August 8, 2025
ES-9607.02

**Subject: Response to Building Permit Review Comments
Cheshire Property
7615 East Mercer Way
Mercer Island, Washington**

City File No. 2503-130

Drawn CAM
Checked SSR
Date 06/11/2025
Proj. No. 9607.02
Plate 2

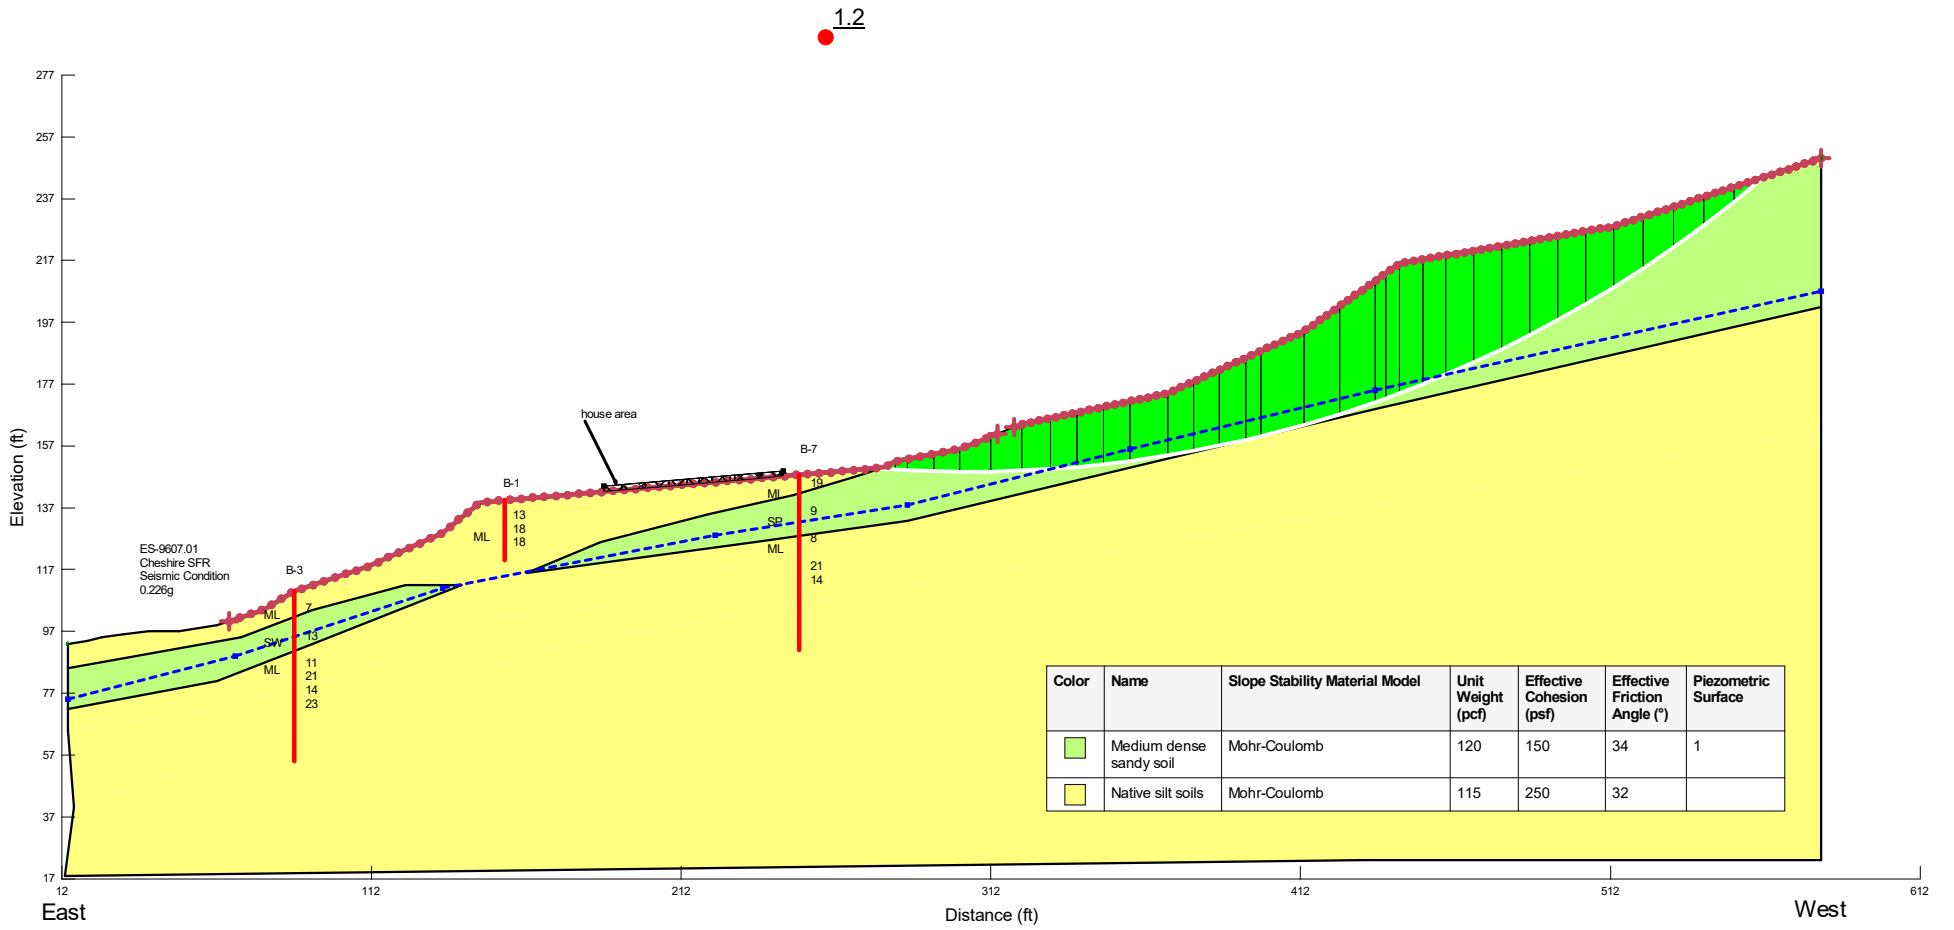
Please have the geotechnical engineer of record provide a scaled site plan with elevation contours showing the boring locations in the geotechnical report. Please include in a design memo or revised geotechnical report.

Attached on Plate 2.

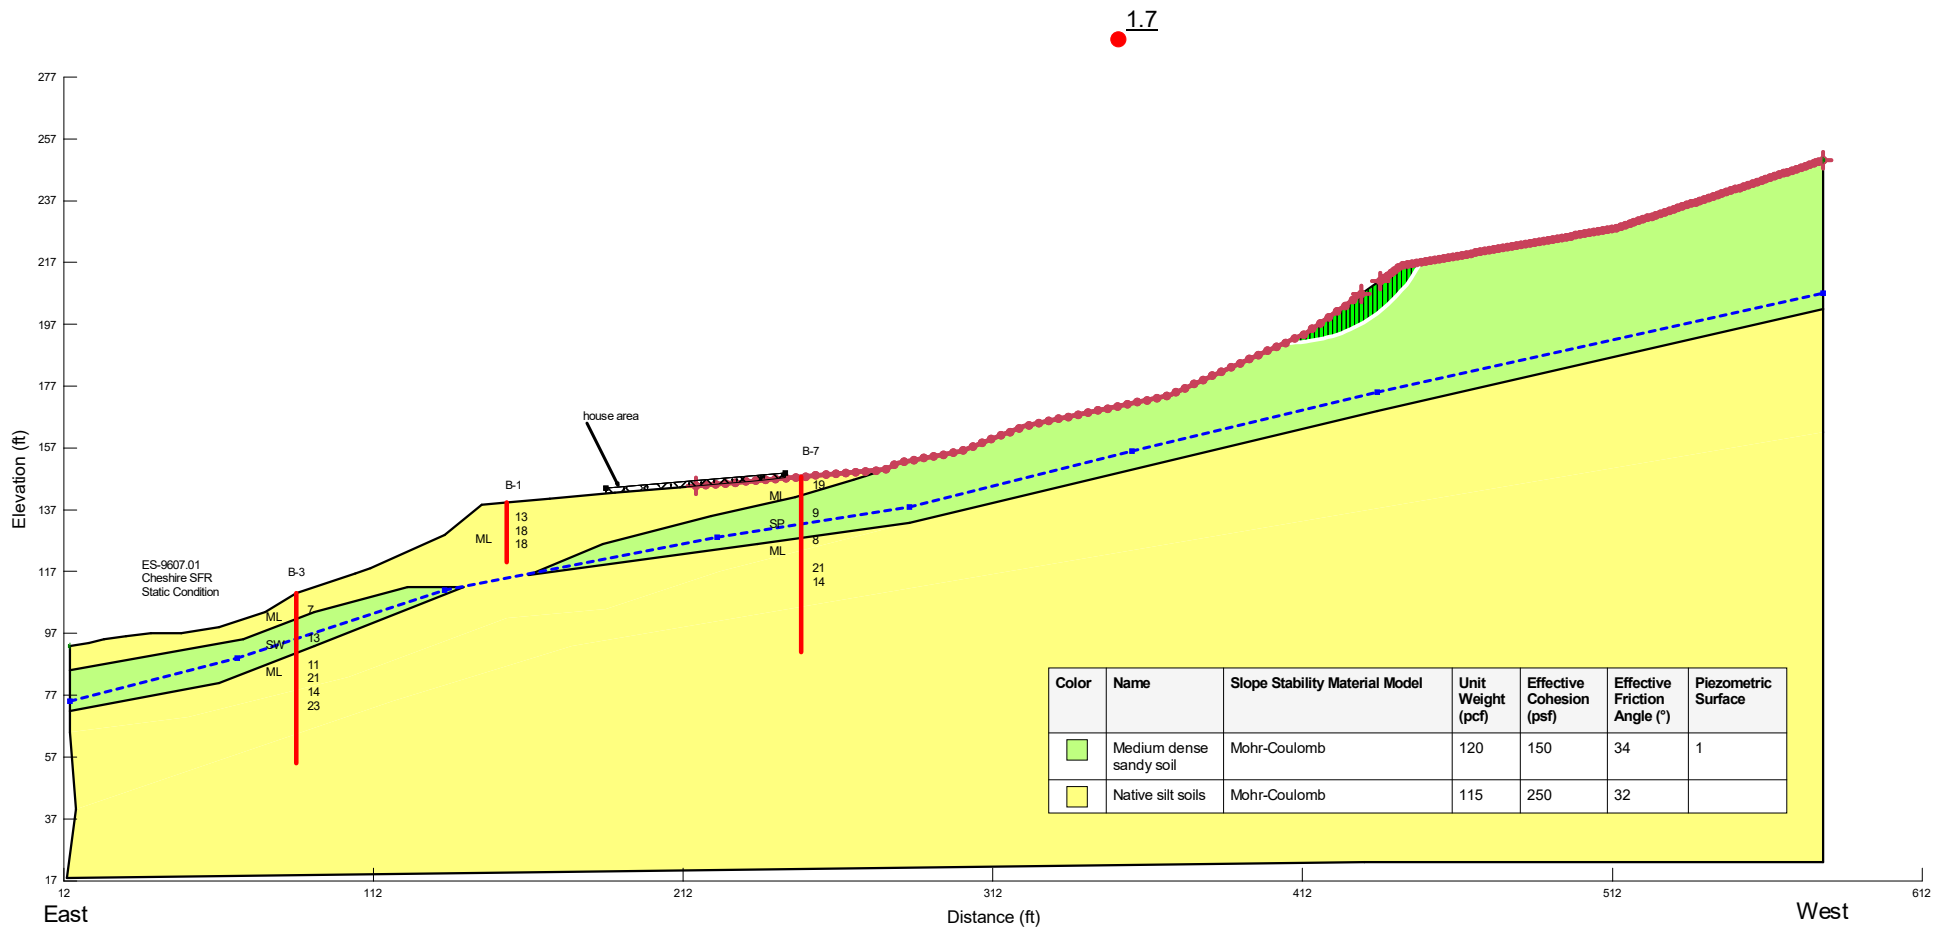
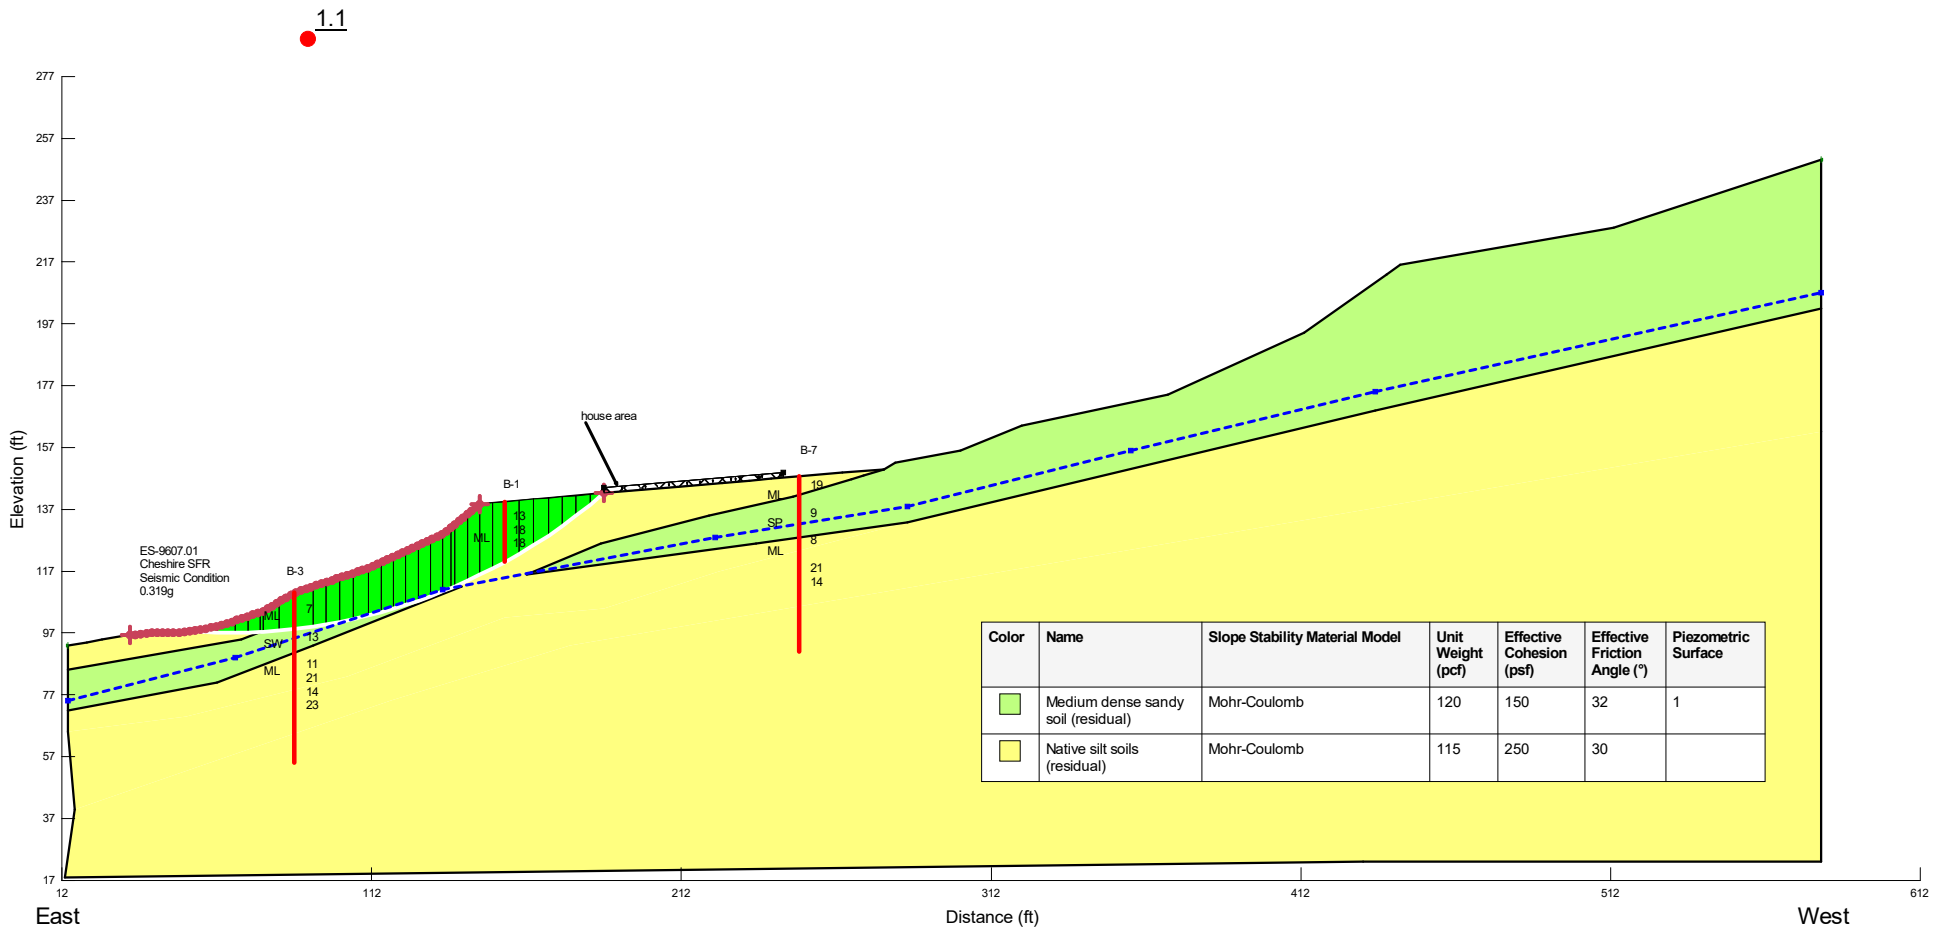
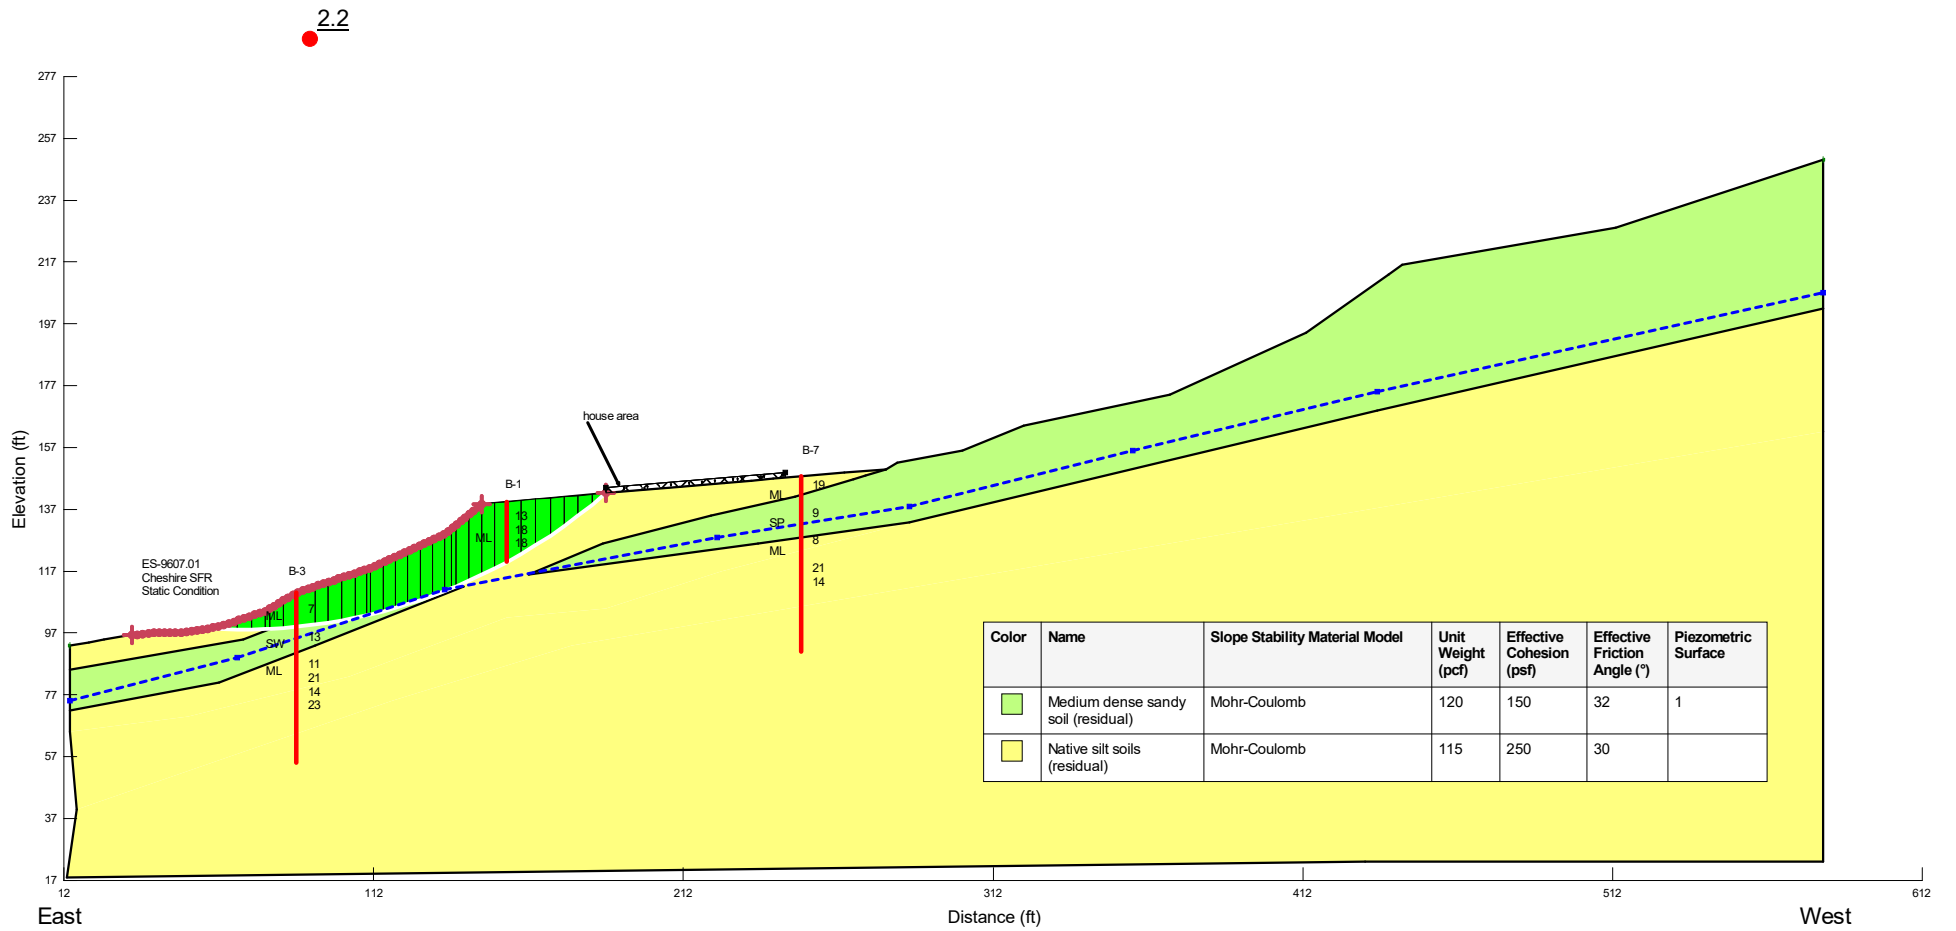
Please have the geotechnical engineer of record provide a slope stability assessment of the entire site (including the slope west of the residence) under static and seismic loading conditions. Please include the computer printout of all the results of the slope stability analyses. Appendix B of the geotechnical report did not include this information in the submitted report.

Updated slope stability modeling parameters are attached.

Updated slope stability analyses attached evaluated the overall site as well as features adjacent to the building pad. The results of the stability analyses suggest that adequate factor of safety is maintained on the site such that impacts to the structure will not be increased. The search parameters were chosen to evaluate the entire slope area within the cross-section. The critical failure surface minimum factor of safety maintains the minimum acceptable value, suggesting the site remains stable. The new home will be supported by pipe piles and battered helical anchors that will further protect the building from earthquake forces and resulting potential ground deformation. A catchment wall with two feet of freeboard is included in the latest submittal for the base of the slope to the west. This element will help protect the residence from debris flow failure, although modeling suggests this occurrence is extremely unlikely.
